## Response letter to Reviewer#1

Thank you for sending me the manuscript: "Quantifying the impacts of the Three Gorges Dam on the spatial-temporal water level dynamics in the Yangtze River estuary" by Huayang Cai for review, which I read with great interest.

Figure R1. Relationship between water level and river discharge at the DT hydrological station (a) and that between residual water level slope for the whole estuary and river discharge (b).

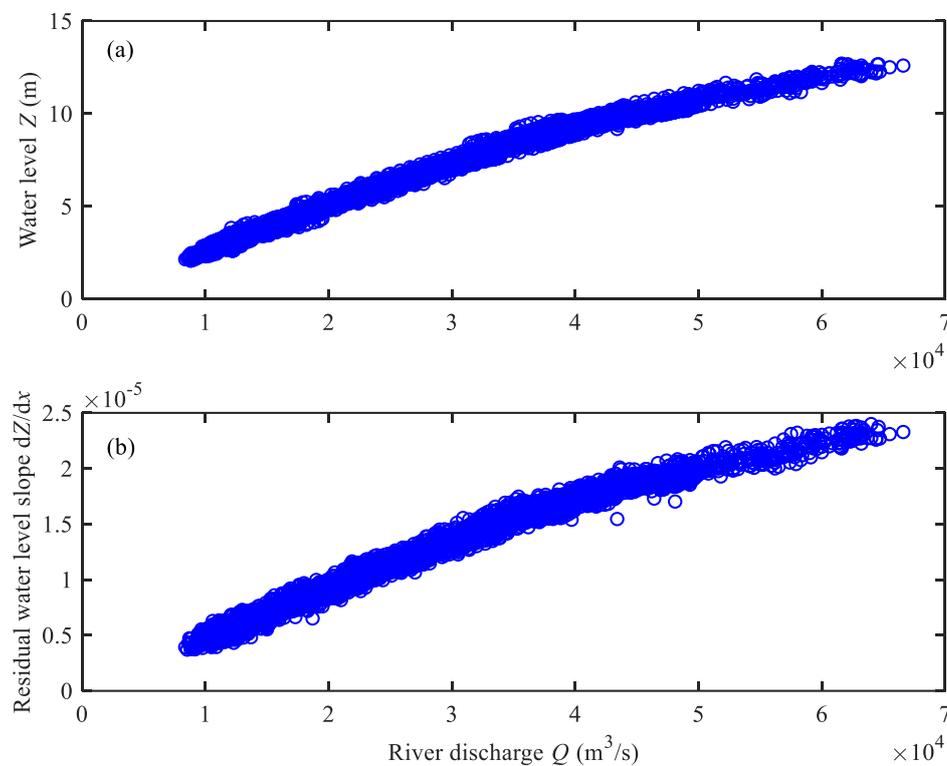
1. The regression model includes both discharge and water level at the upstream station. As they depend on each other, the model is not parsimonious. As a consequence, the columns for  $Q$  and  $Z_{up}$  of the regression matrix will be close to collinear so that small changes (errors) in the data can result in large changes in the coefficients  $\alpha$  and  $\gamma$  even if the fit is good. Possible changes of the coefficients over time might thus be regression

artefacts. This should be ruled out by verifying that  $Q_{up}$  and  $Z_{up}$  are not strongly correlated.

- If the correlation is weak, then the model is robust, but then it would be insightful to elaborate on why the upstream water level and discharge are unrelated. The comment "influenced by the dynamics of [] tributaries" (l. 119) is unclear. The water level is uniquely determined by the backwater curve as long as the daily averaged water level does not change rapidly in time. Therefore, tributaries upstream of the inflow boundary influence downstream levels only through their discharge. Do the authors refer to tributaries downstream of the upstream station?

Our reply: It can be seen from Figure R1 below that the correlation between  $Q_{up}$  and  $Z_{up}$  is indeed strong. However, we observe that the daily averaged water levels are not uniform for identical river discharge (see Figure R1a) due to the external forcing, either the potential influence induced by the tidal forcing or the exerted residual water level slope upstream of the DT hydrological station. Actually, the observed water levels at DT hydrological stations were influenced by both the residual water level slope upstream of the inflow boundary (owing to the relative importance of river discharge between the main stream and the tributaries, especially during the flood season) and that downstream of the inflow boundary (owing to the tidal forcing, especially during the dry season). To account for the influence of residual water level slope, in the previous manuscript we have explicitly introduced the  $z_{up}$  into the regression model.

Figure R2. Comparison between predicted and observed daily averaged water levels for both the pre-TGD and post-TGD periods at different gauging stations along the YRE by means of Equation R1: (a) Jiangyin (JY), (b) Zhenjiang (ZJ), (c) Nanjing (NJ), (d) Maanshan (MAS), (e) Wuhu (WH).

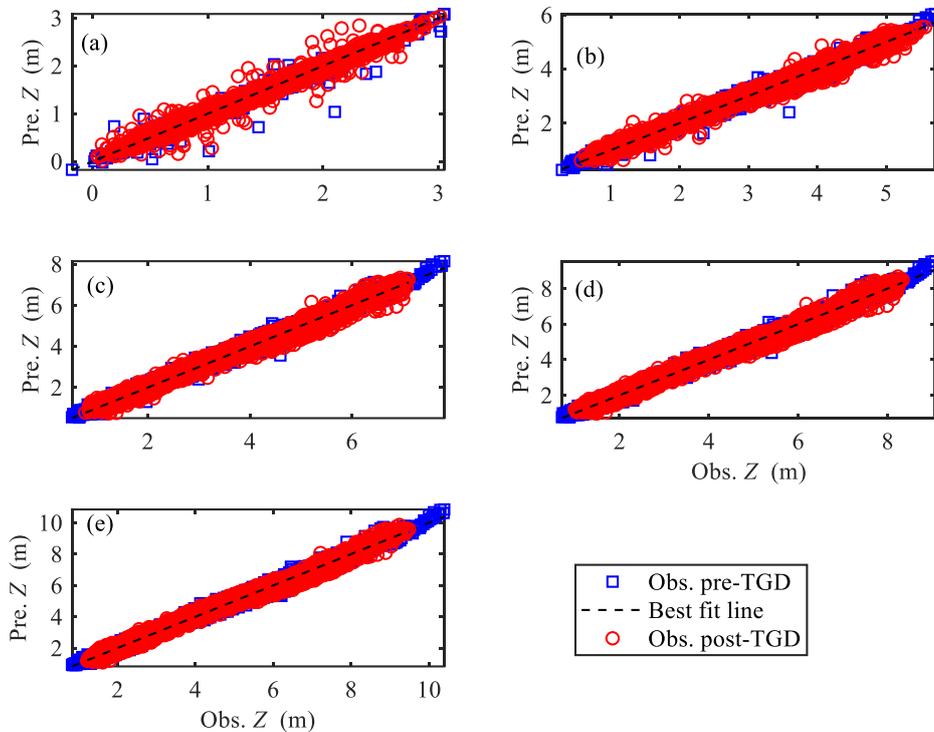
- If the correlation is strong, then it is better to replace the terms  $\alpha Q + \gamma Z_{\text{up}}$  with the non-linear term  $\alpha Q^b$ . This model is less ambiguous. In my personal experience, the coefficients  $a$  and  $b$  of the non-linear model also give much more insight into the influence of the river discharge on the mean water level along tidal rivers.

Our reply: We very much appreciate the comments raised by the Reviewer. In this case, the regression model can be described by the following equation:

$$Z = Z_0 + \alpha Q^b + \gamma Z_{\text{down}} \quad (\text{R1})$$

where the potential influence of  $Z_{\text{up}}$  on water level dynamics is implicitly accounted by the nonlinear term  $\alpha Q^b$ . It can be seen from Figure R2 and Table R1 that the model performance is more or less the same as the original triple linear regression model, except that the RMSE values are slightly larger at NJ, MAS and WH stations (ranging between 0.17 and 0.21 m) than those using the triple linear regression model (ranging between 0.11 and 0.15 m).

Figure R3. Autoregressive power spectral density estimate of the daily averaged water level observed at TSG gauging station

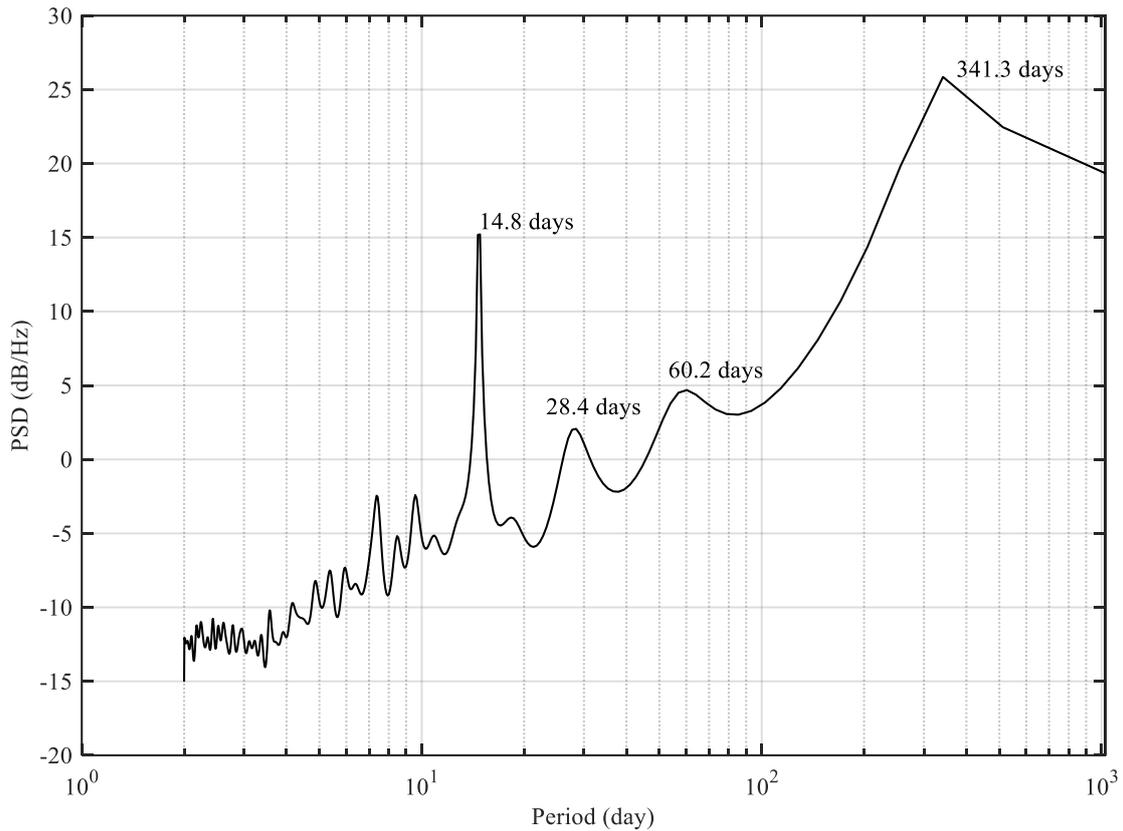
2. The regression model does not include the effect of the tides on the mean water level. However, this effect is not negligible during periods of low river flow (LeBlond, 1978). This introduces a systematic error. As the Three Gorges dam increased river discharge during the low flow season, this can bias the results. It is, therefore, reasonable to include the influence of tides on the mean water level in the regression model. For example, Kukulka and Jay (2003) suggest the regression model linear in  $h^3$ :

Our reply: Actually, the potential effect of the tides on the mean water level is implicitly considered by the  $Z_{down}$  term, which is typically featured by a spring-neap cycle. Figure R3 shows the autoregressive power spectral density estimate of the daily averaged water level observed at TSG gauging station, where significant periodic cycle of 14.8 days was observed.

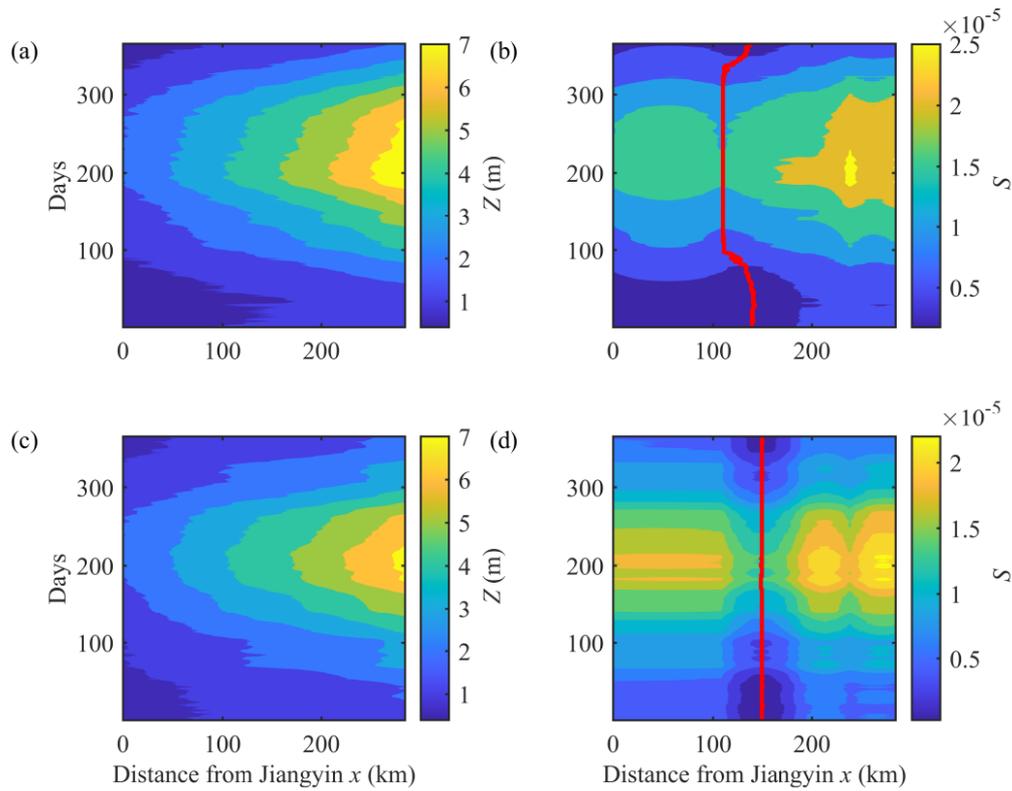
4. Interpolation of slopes and uncertainty estimates (Figure 4 and 5, lines 190\_)

- There is a mistake in the slope calculation. The values should be in the order  $10^{-5}$ , not  $10^{-8}$ . The distance between the stations was probably not converted from km to m.

- Determining the slope from by higher-order (Hermite) interpolation is not meaningful here. This is because the error (of the slope) is amplified at the interpolated values between the stations. As a consequence, the interpolated slope has unrealistic local extrema at the midpoints between stations (Figure 5). The error of the cubically (Hermite) interpolated slope at the midpoint between stations is about 1.8 times as large as the errors of the levels at the stations. Since the error of the levels is about 10%, the error of the slope is about 20%. The local maxima of the slope, as well as the difference between the pre- and post-TGD period as indicated in Figure 5 are therefore insignificant. The interpolation error (of the slopes) can be considerably reduced by calculating the slopes at the midpoint between two stations and then linearly interpolating the slopes between the midpoints. In this case the error of the slope is only 0.7 times that of the error in levels. If the authors want to retain cubic interpolation, then the spurious extrema can be suppressed by fitting the 4 coefficients of the cubic polynomial with all 5 stations in a least squares manner.

**Our reply:** You are right! In the revised manuscript, we shall correct this mistake (see Figure R4 below).

Our reply: Many thanks for the reviewer's comments on the interpolation of the results. Actually, we only interpolated the daily averaged water level along the estuary, while the slope is computed on the basis of the interpolated water level using the Matlab

“gradient.m” function. However, it is true that the unrealistic local extrema are mainly due to the amplification of the error of the interpolated water level.

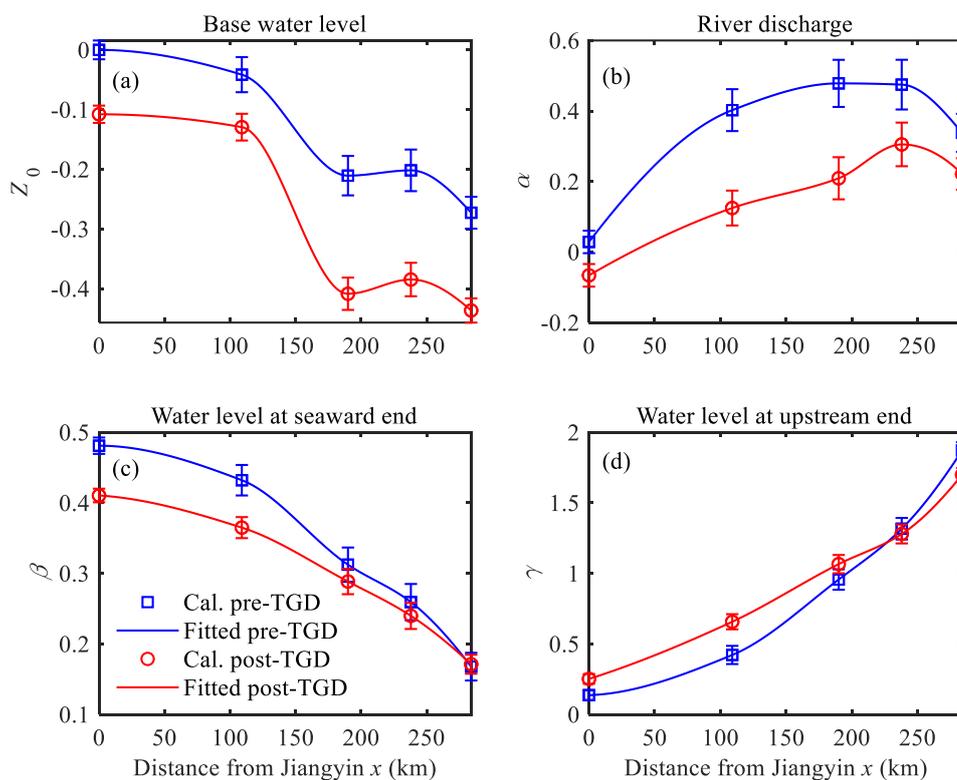
- As the model is not parsimonious, it might fit well even if the regression coefficient are uncertain, as multiple parameter combinations can result in similar good model performance. A good way to assess the uncertainty is bootstrapping (Efron and Tibshirani, 1994). Simply split the time series into blocks comprising of one month, this reduces the effect of serial correlation. When there are  $n$  blocks, randomly choose  $\sqrt{n}$  blocks and fit the model. Repeat this a few hundred times. The standard error is simply the standard deviation of the estimated parameters. The standard error of the coefficient, predicted levels and slopes can then be indicated with error bars in Figure 3 and 5. The cubic interpolation results in larger errors at midpoints between sections, so errors bars are best placed there.

- Figure 3 Add subplots titles, like Discharge, Downstream level, Upstream level so that the figure can be interpreted without looking up the meaning of the coefficients  $\alpha$ ,  $\beta$ ,  $\gamma$ .

■ Figure 3 begins from Jiangyin→upstream of Jiangyin

Our reply: We very much appreciate the reviewer’s comments on the quantification of the model uncertainty. Actually, since we used the default multiple linear regression function “regress.m” in Matlab, it is possible to output a matrix of 95% confidence intervals for the coefficient estimates, which is similar to the adoption of bootstrapping. In the revised manuscript, we shall update the Figure 3 by including the error bar for each coefficient (see Figure R5 below).

Our reply: We agree with the reviewer's comment. In the revised manuscript, we shall include the subplots titles (see Figure R5 above).

Our reply: We agree with the reviewer's comment.

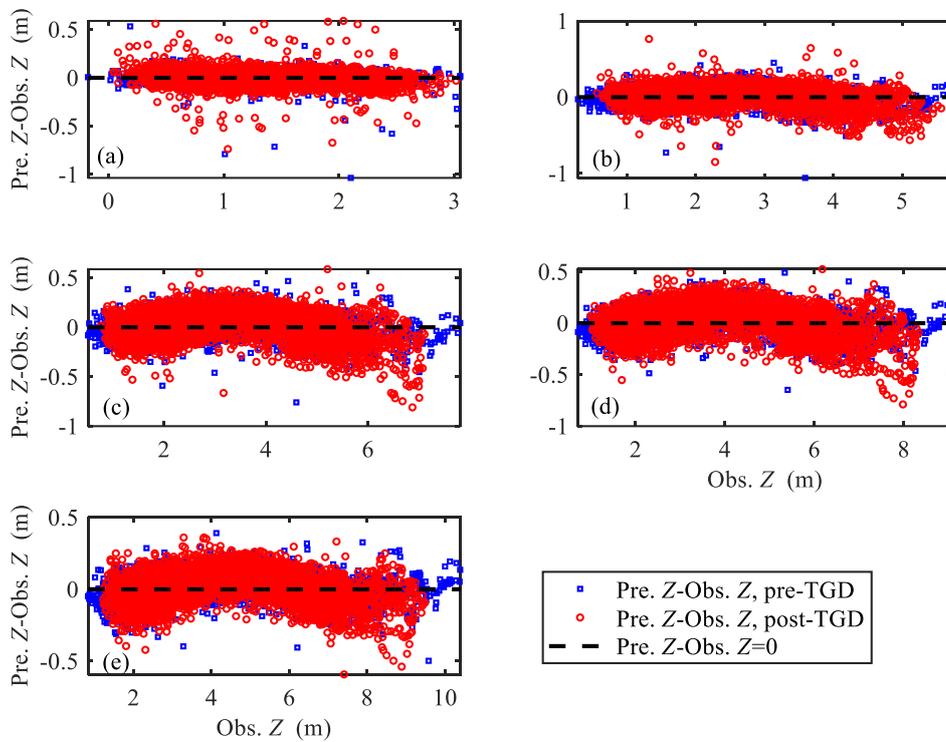
- Figure 2 It would be more meaningful to plot  $(Z_{\text{pred}} - Z_{\text{obs}})$  vs  $Z_{\text{obs}}$  and to use smaller dots which do not overlap that much. This would reveal better any systematic variation.

Our reply: We agree with the reviewer's comments. In the revised manuscript, the Figure 2 will be revised as follows (see Figure R6 below).

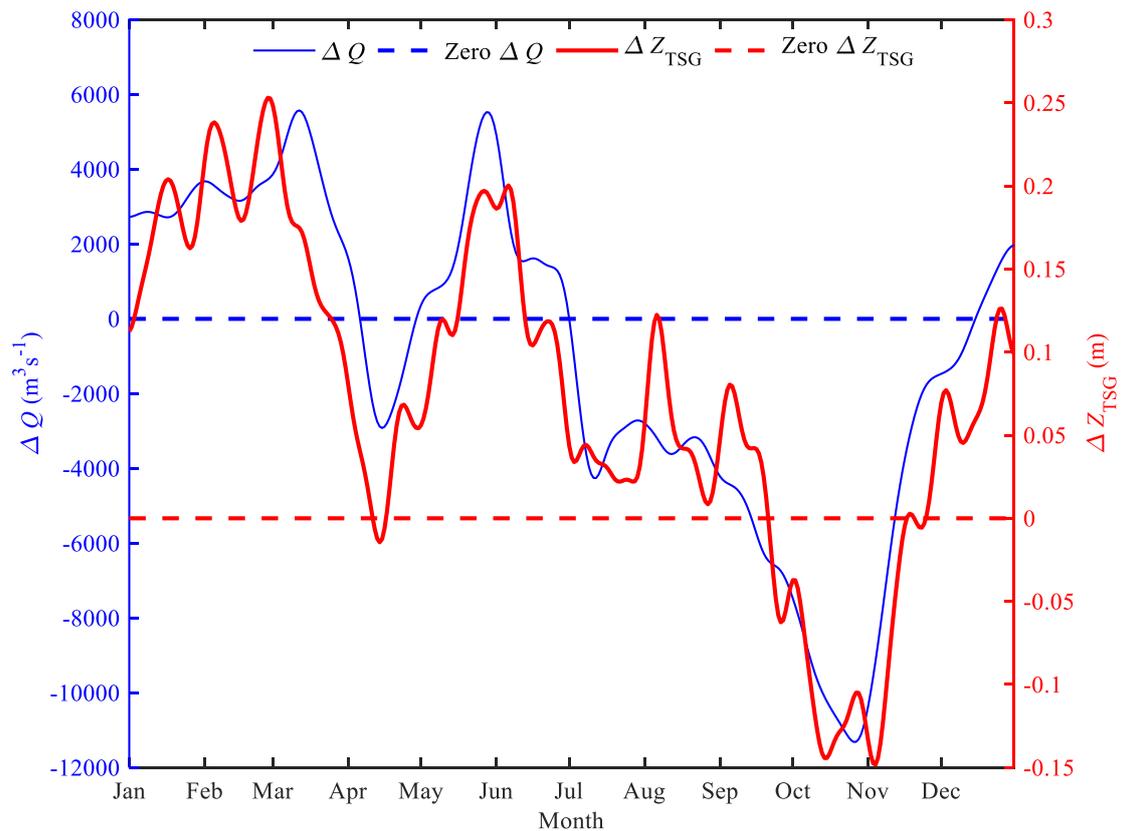
■ Figure 7 The average annual average hydrograph of the post-TGD period is corrupted by high-frequent fluctuations of the hydrograph. The graph would be clearer if the fluctuation is removed it through by smoothing with a sliding window. A triangular window with a width of 30 days seems appropriate. Smooth the data for the pre-TGD period as well, for better comparison.

Our reply: We agree with the reviewer's comments. In the revised manuscript, the Figure 7 will be revised as follows (see Figure R7 below).
